Re: Petition 1406A – Responses to CSC Interrogatories

NuPower Bridgeport FC, LLC (“NuPower”) hereby submits to the Connecticut Siting Council (“Council”) its responses to the Council’s May 14, 2021 interrogatories (Set 1).

Petition No. 1406A

Petition 1406A  
Attachment CSC-11-1

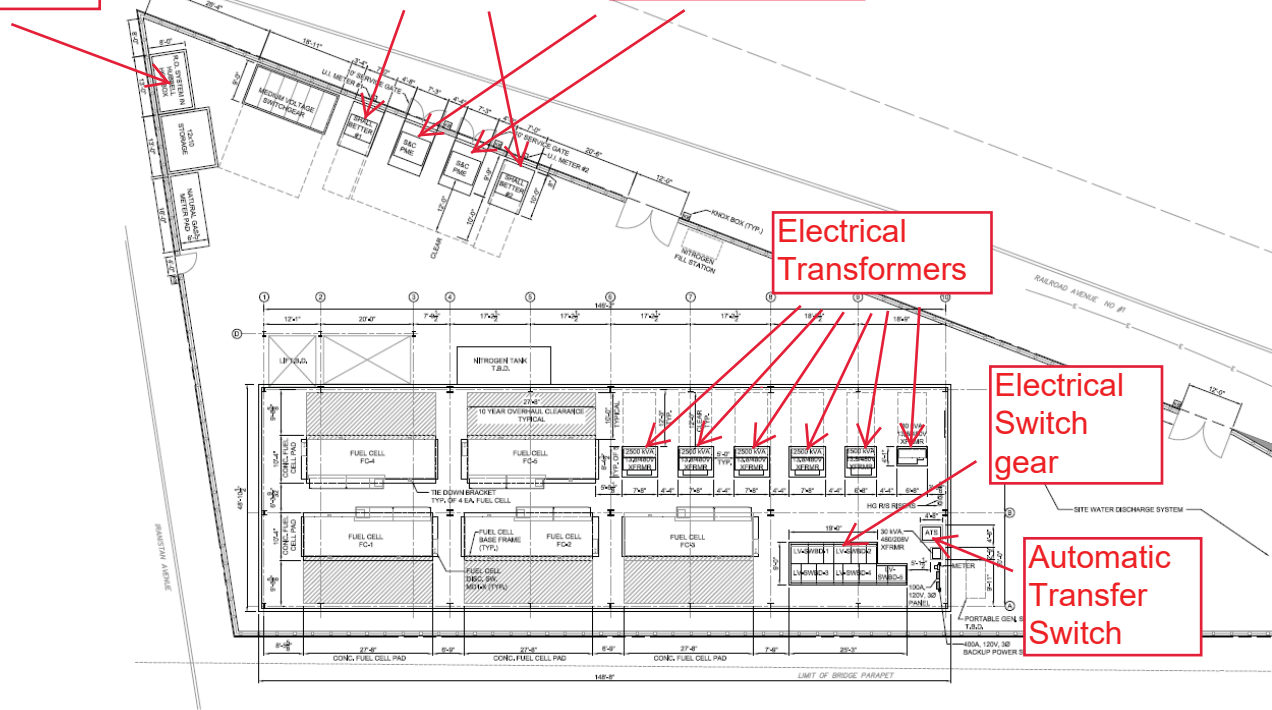
Q- CSC-11: Referring to the Site Plans (GA 1.0), define the equipment abbreviations. What area contains the thermal loop equipment?

A- CSC-11: "R.O. System in Hubbell Hot Box" refers to a reverse osmosis water filtration system.

"ATS" refers to an automatic transfer switch.

"LV-SWBD-1 through LV-SWBD-5" refer to the electrical switch gear.

"SHALL BETTER" refers to the United Illuminating meter cabinets.

"S&C PME" refers to the main electrical switches.

"XFRMR" refers to the electrical transformers.

"T.O. Retaining Wall" refers to the top of the retaining wall.

"T.O. Slab" refers to the top of the slab.

See Attachment CSC-11-1 for a copy of Site Plan GA 1.0 and corresponding labeled equipment.

The thermal loop equipment, consisting of a heat exchanger and an eight by twelve pump station skid, will be located on the far eastern point of the site (on the bottom right corner of Site Plan GA 1.0).
